HMS Alliance, Gosport - Bow access, Cofferdam, and fill

The NMRN have concerns regarding the condition of the cofferdam fill and associated structures supported within (Bow Platform and Forward bow access staircase) site survey's where completed on 17.11.20 approx. 15:00hrs (High water 5.01m ACD at 12:24hrs) and 20.11.20 approx. 07:30hrs (low water 1.50m ACD at 07:51hrs) observations and recommendations are as follows.

**2. Bow platform structure**

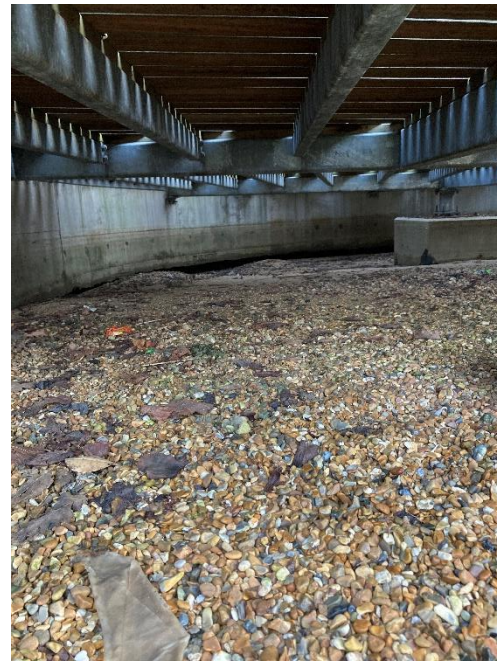
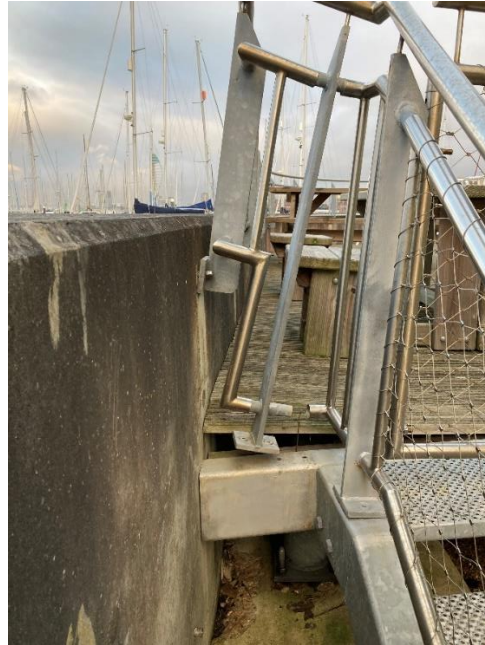
The bow platform to the northern side at the maintenance entrance, has collapsed as the foundation footings below have lowered in height to which has dragged the main front platform support beam down. Where the platform frame is attached to the cofferdam ring beam, this section remains at the installation height, so subsequently the handrailing, decking adjacent is very stressed and has failed in all directions making the whole platform very unstable and not safe for public or staff usage.

Firstly, the bow deck platform should be barriered off and closed from access in the short term for health and safety concerns. The platform structure should then be jacked up, packed, levelled, and temporarily supported as soon as practical.

To two locations, disconnect the foundation block to the base of the staircase and the foundation block closest to the sheet pile ring beam on the northern quarter (under stairs) breakout and remove concrete pads complete. Design, supply and install a new support bracket arrangement for the platform edge beam end, fixed to the cofferdam concrete ring beam. Replace to seven foundation block locations, new type stud connection fixings on natural UHMWPE plate, as per staircase column repair scheme above.

Remove as necessary and make good the stainless-steel handrails, stanchion, and gate to the northern quarter. In addition, manufacture and install an additional stair tread to compensate for the removal of the foundation block at the base of the staircase, the new tread to be as per existing type/ style, suspended at a suitable height off the existing staircase stringers.

High water (17.11.20)

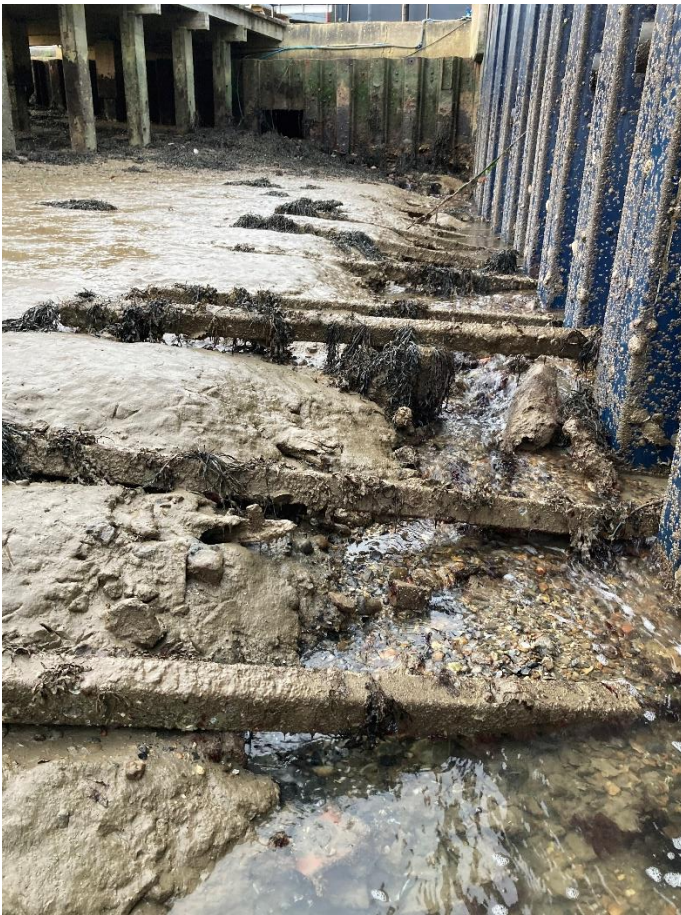
It is thought the cofferdam fill area around the bow has lowered some 200/300mm whereby the granular materials have compacted through the constant ebbing and flowing of tide through its substrates. This action would have started from the outset and although it is in more recent times that the northern platform corner has collapsed it is my assumption that the surrounding supporting decking/ handrailing has been over stressed for a considerable time to which has finally given way in more recent times.

Transition joint cofferdam to ramp (crack)

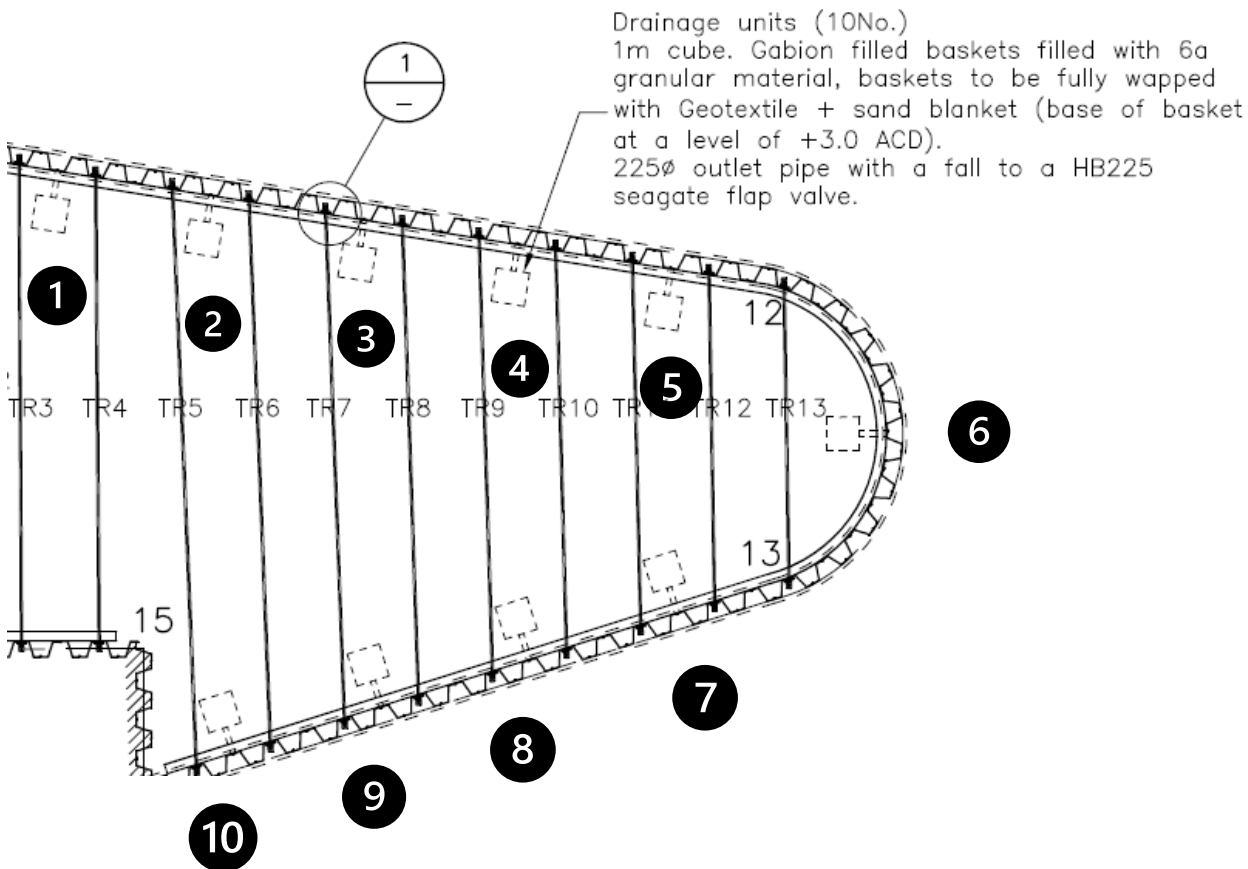
The steel sheet piling has been installed with a good quality paint system and only minor areas of corrosion are present at some clutch joints. All through tie bar end caps seem fully intact. The main capping beam is fully intact, and no significant cracks are present other than one at the transition joint connection at the ramping end.

The concrete crack at the transition point between the main cofferdam ring beam and casted ramp wall should have a larger expansion joint between to allow movement (hence the joint has cracked, and a section has broken away). Make good with a concrete repair locally and increase the gap between the two concrete casted sections to a 15mm opening as far as access allows down to ground level, insert suitable expansion joint material (fibreboard) and seal with a suitable mastic sealant.

Ramp end

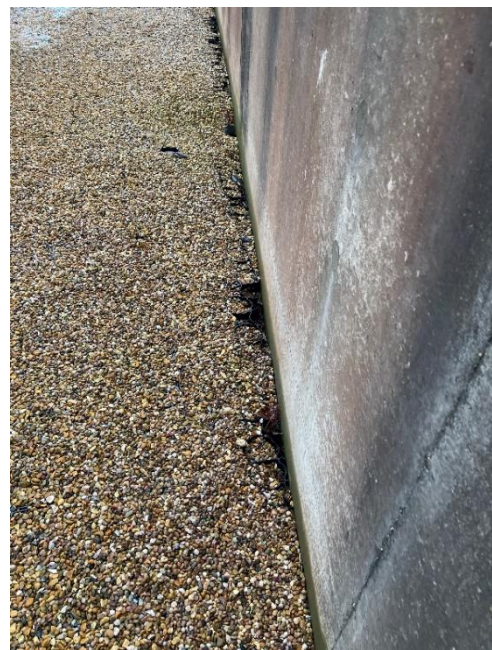
The cofferdam fill ramp area (western end) since construction has now established itself with fine granular materials so allowing growth of weeds, moss, and alike vegetation. To each of the main boat support piles (two set of four), the fill material has compacted and lowered as well as to some of the perimeter edging to the cofferdam ring beam. The fill area below the bow platform is significantly lower than the main fill by circular 500mm although this was the case (Refer to Drg. MLD 12-121-10 AB) once fill was completed. area installed at a lower area and has reduced in high some 300/400mm at the ring beam edge.

Compacting materials under main pile sets

Cofferdam ring beam fill material compacting around edges

To various areas of the cofferdam fill (western ramped area mainly) remove all weeds and vegetational growth, apply strong weed killer.

To the cofferdam fill areas sunken around the main support piles, under platform deck and ring beam edge, replenish the fill levels back up to 4.9m ACD & 4.4m ACD under platform deck area so in accordance with intended design levels. Fill material being a 10mm pea shingle aggregate, estimated 5 cubic metres required.

Typical staircase foundation pad with new type of connection/ support

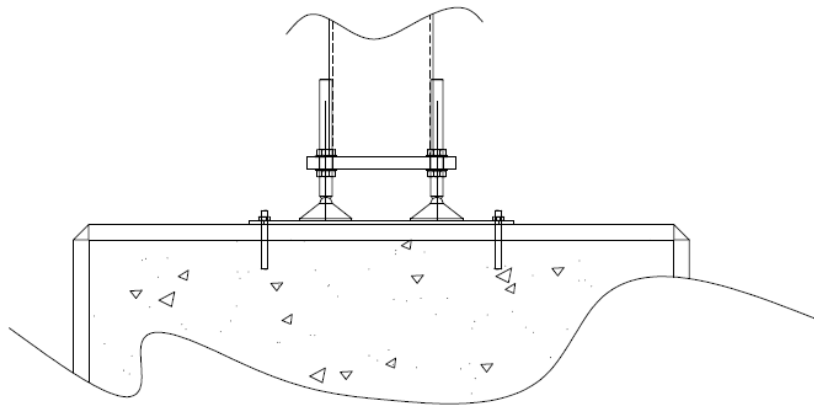
The bow access staircase is currently in contact with the boat (HMS Alliance) and it is assumed has been touching/ leaning on the hull for some-time indicating the outer most foundation pad could be inactive/ unsupportive as the foundation pad is secured/ suspended from the column base feet adding additional load/ stress to the hull contact point and staircase structure assembly itself.

The forward staircase should be jacked of the hull using the existing stud fixing arrangements on each foundation pad and add additional steel shim plates as necessary as soon as practical. If the above is not achievable then additional measures should be actioned, i.e. Provide suitable temporary support systems to the access staircase to enable further works and continuation of use (install temporary support systems i.e. Acrow support props and clipped scaffold)

Once the staircase has been adjusted and stabilised (not in contact with HMS Alliance) remove and replace the existing stud connections with stainless steel adjustable jacking feet on the northern foundation pad (closest to Alliance), to which each column support should have a natural UHMW-PE 10mm thick plate fixed to the foundation pad to act as a bearing plate for the new adjustable stud feet to bear onto.

2. Bow platform structure

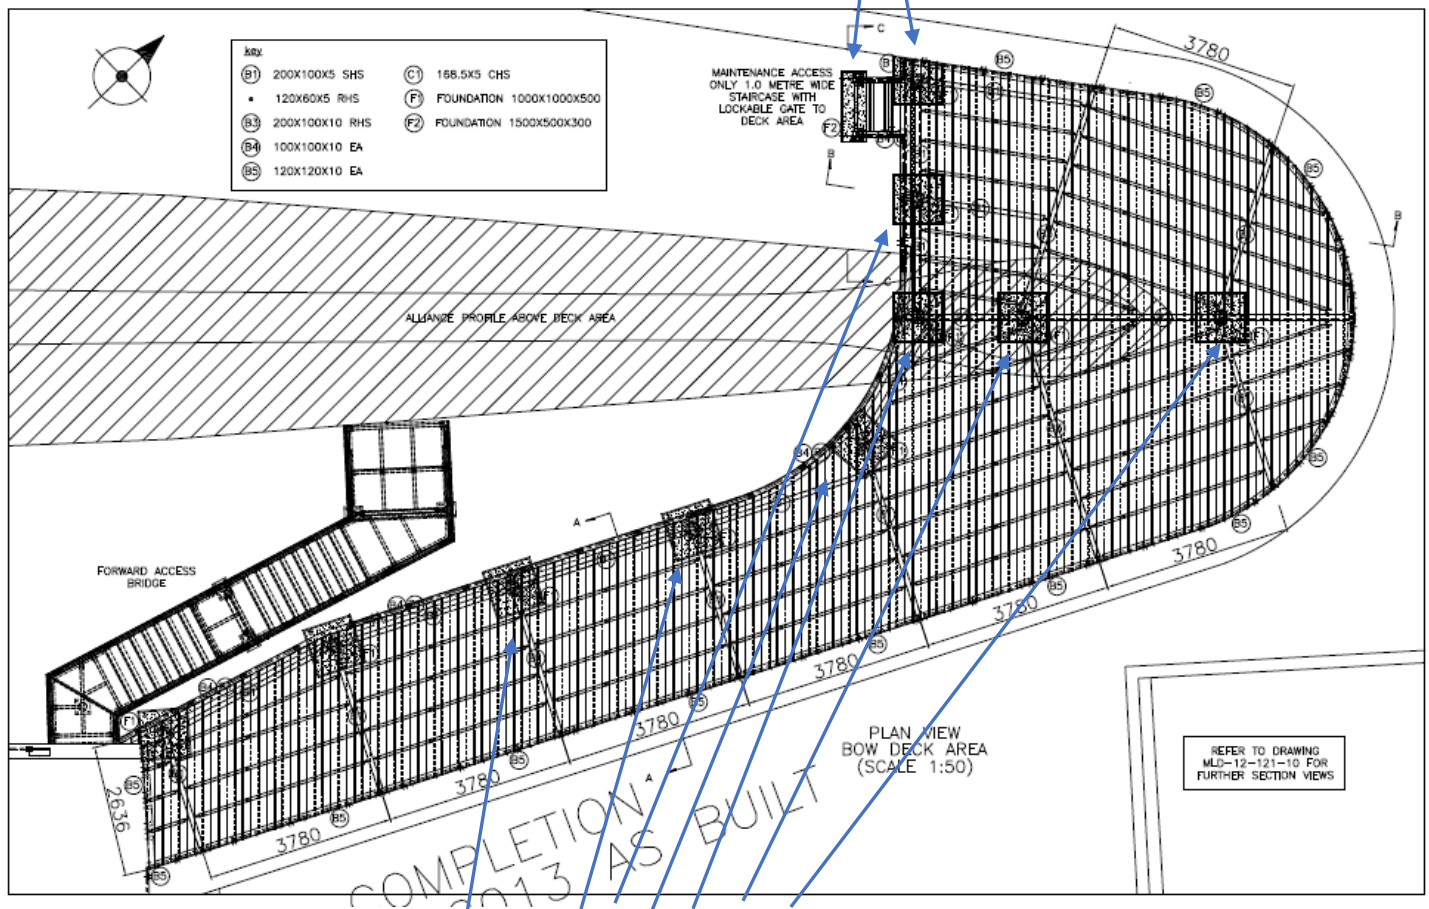
Remove 2x concrete blocks complete and fit new support bracket

Install 7x new type of adjustments to each foundation block

Note – For all new adjustable stainless-steel stud fixings, each should have bimetallic corrosion protection (Isolation between dissimilar materials using nylon washers or similar) and Denso tape wrapped around threads for future maintenance.
